OBSERVATION

Crumhach Wind Farm, Co. Sligo — An Coimisiún Pleanála Case 324561

Blair Feeney Limited, Main Street, Dromore West, Co. Sligo

Re: Case 324561 — Proposed Crumhach Wind Farm, Co. Sligo

Figure 2 — Staff car park and its entrance, marked by the observer on the applicant's swept path drawing for Location 15 (Digital Land Surveyors Ltd, 2026, Sheet 002 of 007).

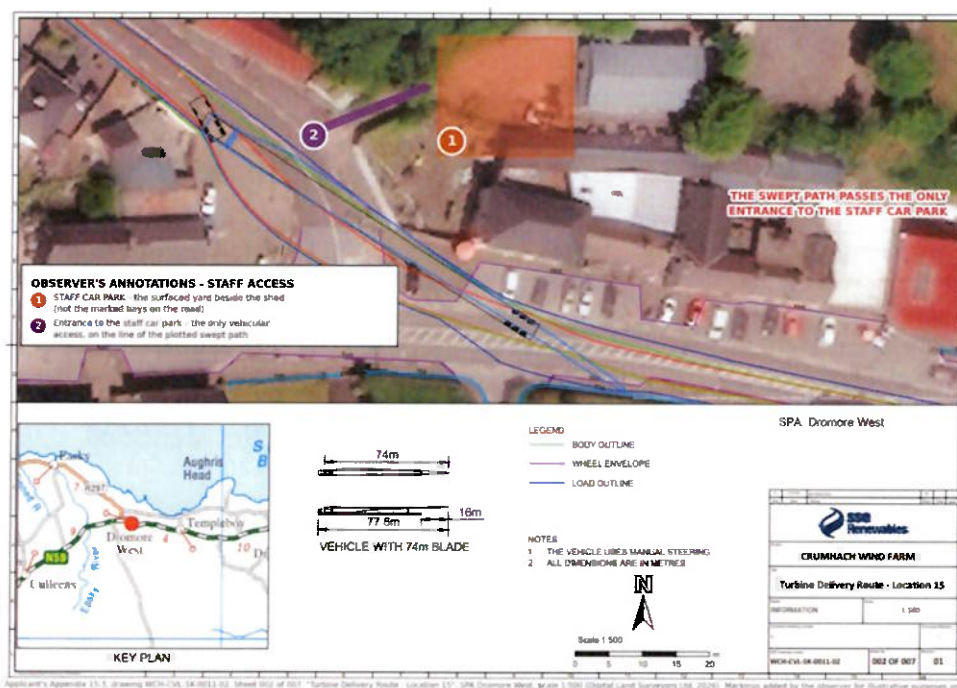
1 — Our staff car park: the surfaced yard immediately beside the shed, in the upper part of the drawing. (The marked bays visible on the roadside are a different area.) Approximately thirty staff park there, the first arriving from 6 a.m.

2 — The entrance to the staff car park, taken directly off the public road. It is the only vehicular access to the car park, and lies on the line of the plotted swept path.

The applicant has therefore plotted the swept envelope of a 77.8 metre manually steered vehicle across a shared public-facing car park and the only entrance to a car park used daily by thirty

employees, without recording in the written assessment that either facility exists, that it is in commercial use, or that any measure is needed to manage the interaction.

The applicant has plotted the manoeuvre past these facilities but has not assessed its effect on them. That assessment should be before the Commission.

Figure 3 — The shared customer car park serving this and the adjoining premises, marked by the observer on the applicant's swept path drawing for Location 15. The applicant's plotted body, wheel and load envelopes cross it.

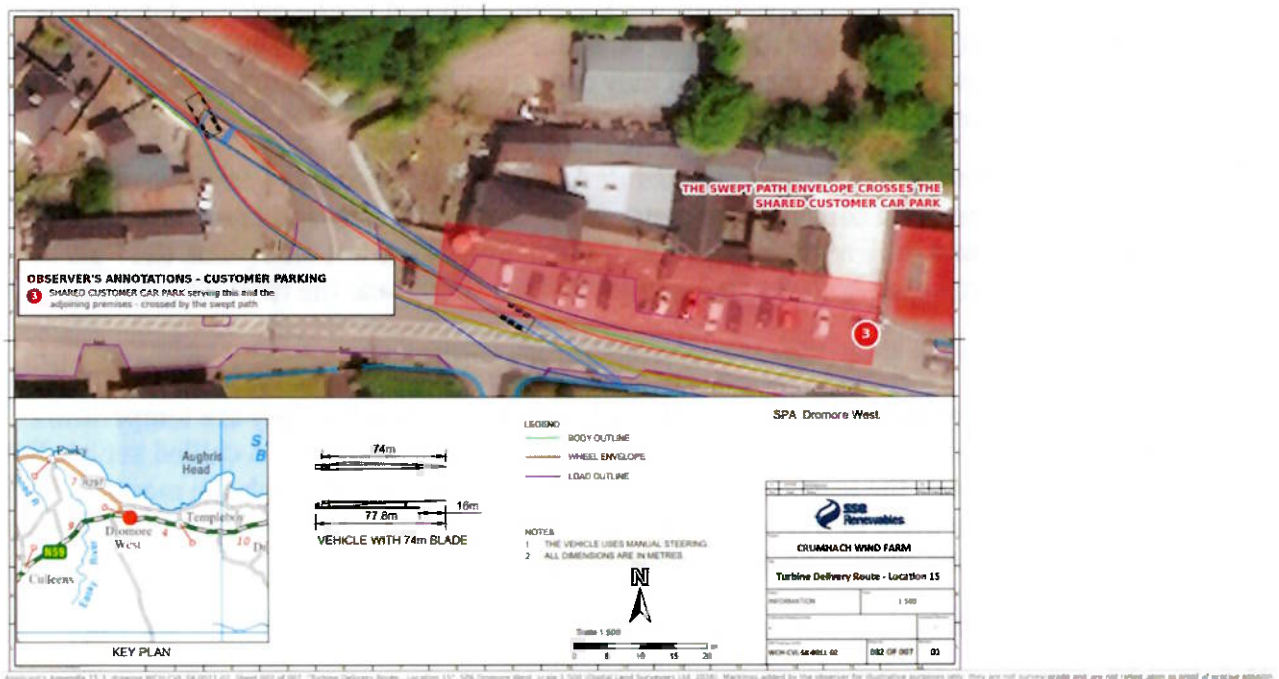
The parking area on the N59 frontage is a shared customer car park serving our premises and the adjoining premises. The applicant's swept path drawing plots the body, wheel and load envelopes of a 77.8 metre manually steered vehicle across it, as marked at Figure 3 (Digital Land Surveyors Ltd, 2026, Sheet 002 of 007).

A vehicle of that length cannot execute the manoeuvre with cars parked within the envelope. The car park must therefore be cleared and closed for each passage of a turbine load, which on the applicant's own figures means a minimum of 45 occasions over nine weeks, and on Chapter 15's account 136 abnormal loads in convoys of three or four.

- Our customers, and those of the adjoining premises, will have nowhere to park.
- We have identified no statement of the duration of each closure, the notice required, who must clear the car park, or what becomes of a vehicle left in it.
- We have identified no alternative parking provision.
- Because the facility is shared, each closure affects several businesses, none of which appears as a receptor in the EIAR.

- Because no clock time is stated for convoy movements, we cannot tell customers when parking will be unavailable.

Taken together, a customer-facing business loses its parking on an unstated number of occasions, at unstated times, for an unstated duration, with no alternative identified, and the Traffic Management Plan does not mention car parking, businesses or premises.

Appendix A — Extract from Appendix 15-3, Autotrack Assessment Drawings

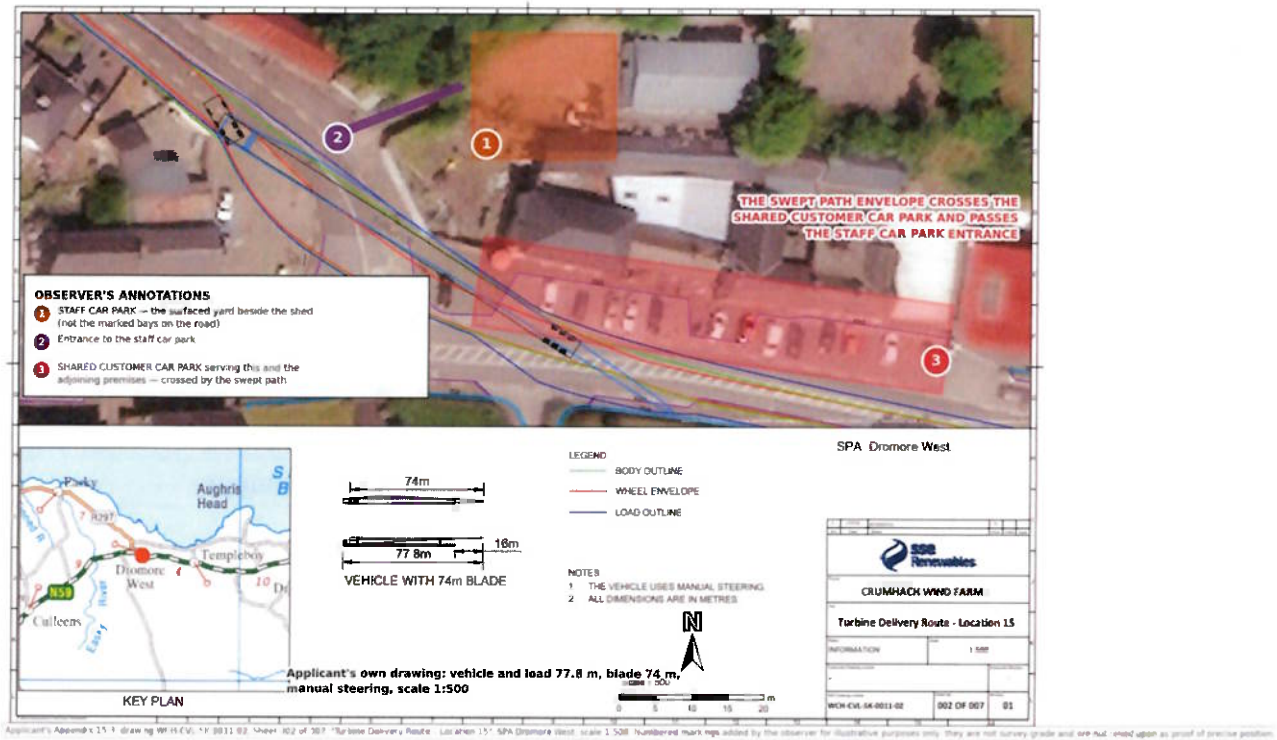
1 — Our staff car park is on the R297, and the applicant's own drawing plots the turbine envelope across its only entrance. Drawing WCH-CVL-SK-0011-02, Sheet 002 of 007 (Location 15, "SPA Dromore West") plots the body, wheel and load envelopes of a manually steered vehicle across the sole access to the yard where approximately 30 staff park, the first arriving from 6 a.m. We have identified no assessment of pedestrian or vulnerable road user movement here, and Chapter 15 does not deal with car parking. The location has been drawn but has not been assessed.

The Autotrack drawing models a manually steered vehicle and load combination of approximately 77.8 metres carrying a 74 metre blade. Our two premises sit on opposite sides of Location 15 at the junction of the N59 and the R297: the service station and fuel forecourt approximately 70 metres to the east of the junction, and the supermarket approximately 75 metres to the west. The manoeuvre therefore takes place between them. Our staff car park access lies on the R297 itself.

The vehicle is longer than the distance it has to travel to reach us. A single combination of 77.8 metres cannot fit within the ground between the junction and our forecourt, because there is only 70 metres of it. When the front of that vehicle reaches our forecourt access, the rear of the load has not yet left the junction, and neither has the rear Garda escort or the traffic control operating behind it. The same is true of the supermarket on the far side of the junction.

A convoy is three to five such vehicles. Three of them, nose to tail and disregarding the gaps between them, extend to some 233 metres, which is more than three times the distance from the junction to our forecourt and more than the length of our entire frontage. For the duration of each passage the whole of that frontage, and both accesses, lie within the movement.

The submitted documents do not assess the length of carriageway a convoy occupies, how long the junction and its approaches are occupied, or the consequences for access to the premises on either side.
